Service Bulletin No: 53-018

**FUSELAGE - MAIN FRAMES****DO A CHECK OF THE MATERIAL SPECIFICATION OF THE FRAME 11 FITTINGS AND, IF NECESSARY, DO A CHECK FOR CRACKS****1. Planning Information****A. Effectivity**

MSN 605 and MSN 617 thru MSN 670.

Check of the Material Specification  
Figure 2

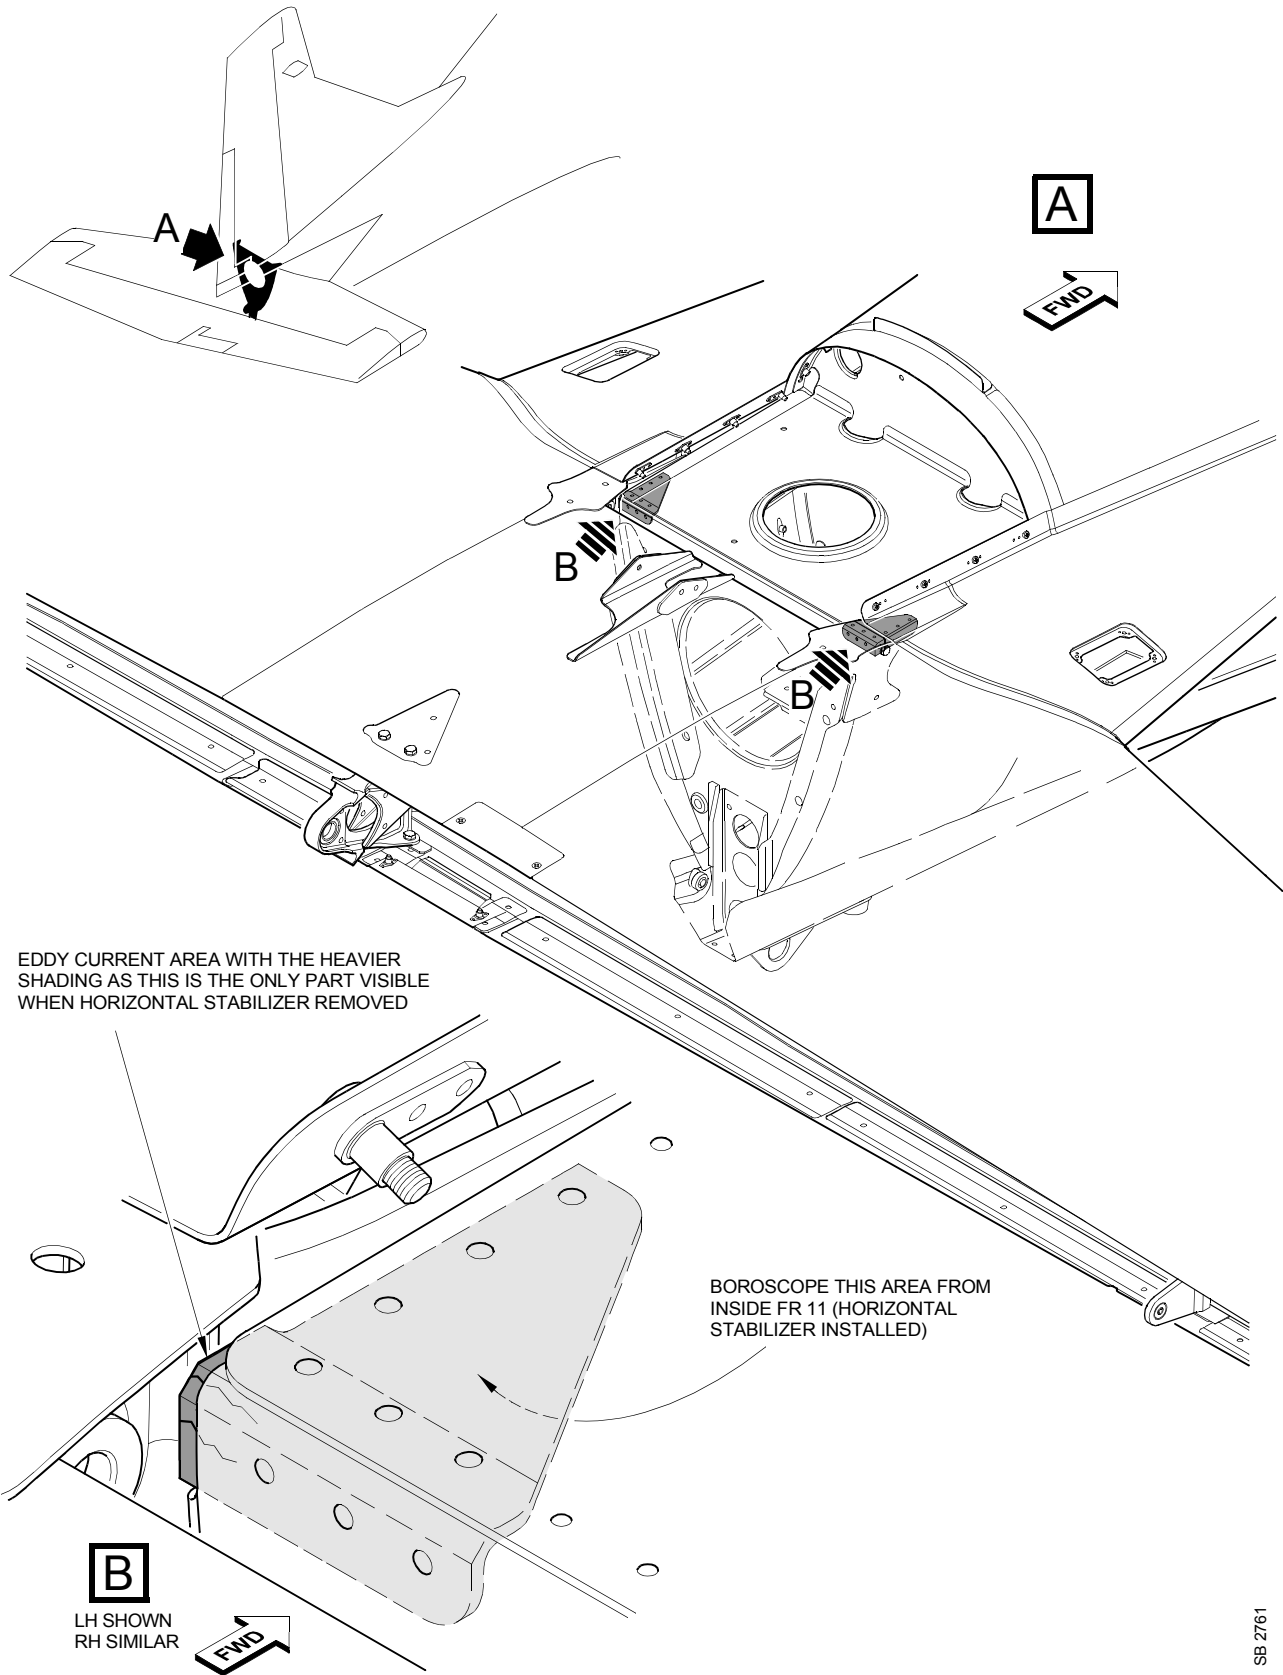
**B. Do the Test to Find the Material Specification (Ref. Fig. 2)**

(b) Put the eddy current probe in position on the left fitting (1) (P/N 112.35.07.489).

**NOTE:** Do this through the hole on FR11. Use a torch and mirror to make sure the eddy current probe is in the correct position.

(d) Compare the value recorded above with the values recorded in Step 3.A.(6) and determine if the fitting is manufactured from AA2024-T351 or AA2124-T851.

Fittings - Crack Inspection (If Necessary)  
Figure 3

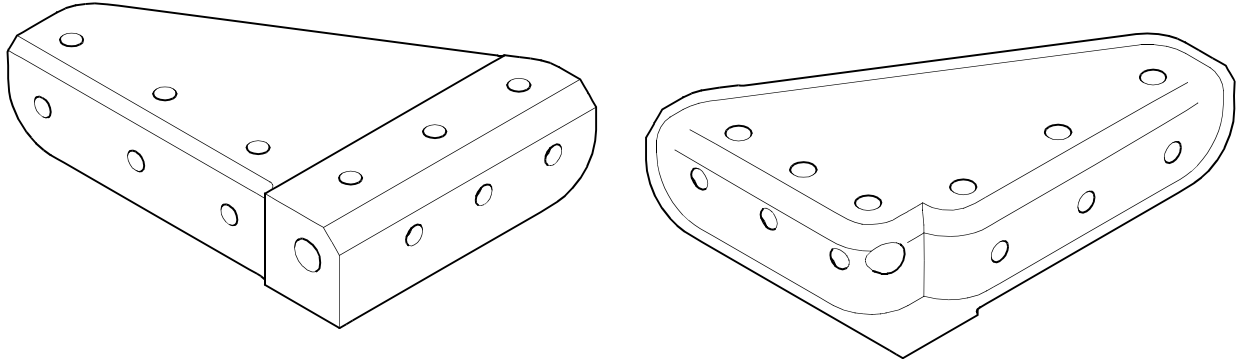
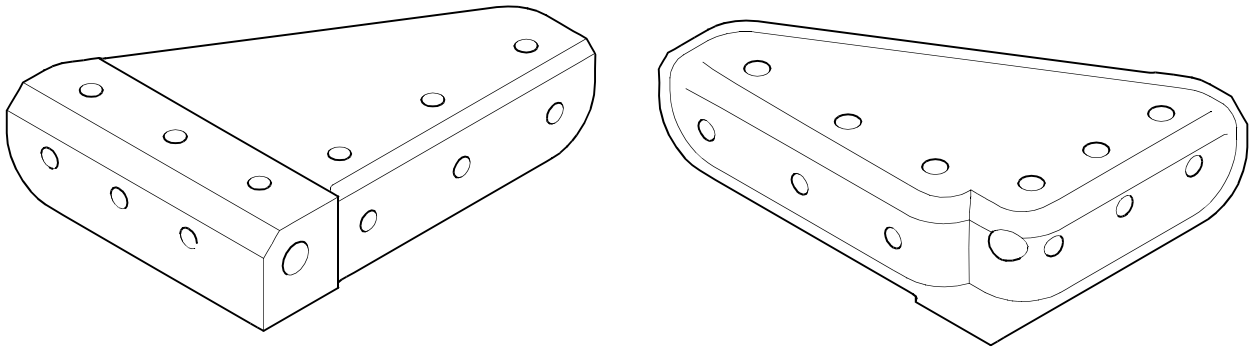
**C. Do an Inspection to Find Cracks with the Borescope and / or Eddy Current (Ref. Fig. 3)**

(1) Obey the manufacturer's instructions and use a borescope to examine the fitting from inside FR11 (looking AFT) for cracks (Ref. Fig. 3).

**NOTE:** Make sure you examine all the visible faces of the fittings.

**NOTE:** If you find cracks, you must replace the fitting before the next flight (Ref. Service Bulletin 53-019).
